APPLICATION NO.	FILING DATE	FIRST NAMED INVENTOR	ATTORNEY DOCKET NO.	CONFIRMATION NO.
10/596,573	10/14/2008	Zhong-Xiang He	BUR920030081US1	7999
32074 7590 05/29/2009 INTERNATIONAL BUSINESS MACHINES CORPORATION DEPT. 18G BLDG. 321-482 2070 ROUTE 52 HOPEWELL JUNCTION, NY 12533				
EXAMINER				
SENGDARA, VONGSAVANH				
ART UNIT		PAPER NUMBER		
2826				
NOTIFICATION DATE		DELIVERY MODE		
05/29/2009		ELECTRONIC

# Office Action Summary

**DETAILED ACTION**

FIG. 1

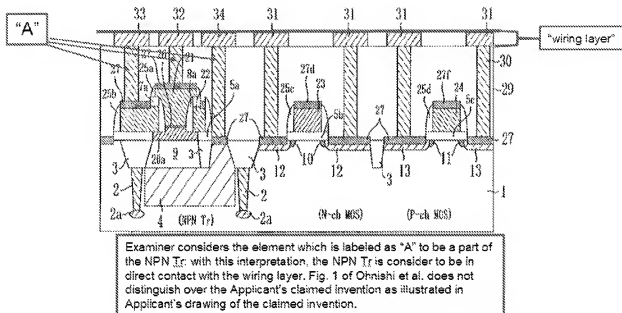
Regarding claims 1 and 12, fig. 1 of Ohnishi et al. discloses an integrated circuit structure comprising:

- a substrate 1;
- a plurality of different height devices (three total: (1) NPN Tr, (2) N-ch MOS, and (3) P-ch MOS) positioned on said substrate 1;
- a passivating layer 29 positioned above said substrate 1 and between said devices;
- a wiring layer (examiner labeled as "wiring layer") above said passivating layer 1, wherein at least one of the tallest (NPN Tr) of said plurality of devices is in direct contact with said wiring layer and at least one of the shorter (N-ch MOS or P-ch MOS) of said plurality of devices is connected

to said wiring layer by a first contact 30 extending through said passivating layer 29.

*NOTE: Examiner considers the element which is labeled as "A" to be a part of the NPN Tr; with this interpretation, the NPN Tr is consider to be in direct contact with the wiring layer. Fig. 1 of Ohnishi et al. does not distinguish over the Applicant's claimed invention as illustrated in Applicant's drawing of the claimed invention.*

Regarding claim 2, with reference to 112 2<sup>nd</sup> rejection, fig 1 of Ohnishi et al. further discloses wherein said at least one of the tallest of said plurality of devices is in direct contact with a first second contact (examiner interpret this be the contact "A" which the examiner labeled in fig. 1 of Ohnishi et al. above) in said wiring layer.

Regarding claim 6, fig 1 of Ohnishi et al. further discloses wherein said wiring layer further comprises wiring (31, 32, 33, 34) within said wiring layer.

Regarding claim 7, fig 1 of Ohnishi et al. further discloses said first contact 30 is connected to said wiring 31 in said wiring layer.

Regarding claim 9, fig 1 of Ohnishi et al. further discloses wherein said at least one of the tallest of said plurality of devices (NPN Tr) comprises a different type of device (NPN Tr) than said at least one of the shorter (MOSFETs) of said plurality of devices.

Regarding 10, with reference to 112 2<sup>nd</sup> rejection, fig 1 of Ohnishi et al. further disclose wherein the top of said at least one of the tallest (which the examiner interpret to be the top of element "A" as labeled in fig. 1) of said plurality of devices is substantially coplanar (the top of "A" is coplanar) with the top of said passivating layer 29.

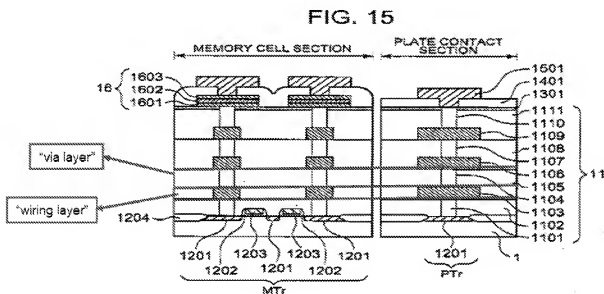
However, fig. 15 of Mori disclose a discloses an integrated circuit structure comprising: a substrate 1; a plurality of devices positioned on said substrate 1; a passivating layer 1102 positioned above said substrate 1 and between said devices; a wiring layer (examiner labeled as "wiring layer") above said passivating layer 1.

Fig. 1 of Mori further discloses comprising a via layer (examiner labeled as "via layer") above said wiring layer, wherein said second contact 1104 is directly connected to said via layer.

Regarding claim 4, with reference to 112 2<sup>nd</sup> rejection, fig. 15 of Mori further disclose wherein said second contact extends through said via layer to said wiring layer.

Regarding claim 5, with reference to 112 2<sup>nd</sup> rejection, fig. 15 of Mori further disclose wherein said second contact is positioned within said via layer.

Regarding claim 8, with reference to 112 2<sup>nd</sup> rejection, fig. 15 of Mori further discloses where said at least one of the tallest of said plurality of devices is in direct contact with a wire in said wiring layer (made of aluminum- see par [0074]) and said

second contact (Tungsten - see par [0068]) within said via layer comprises a different material than said wiring within said wiring layer.
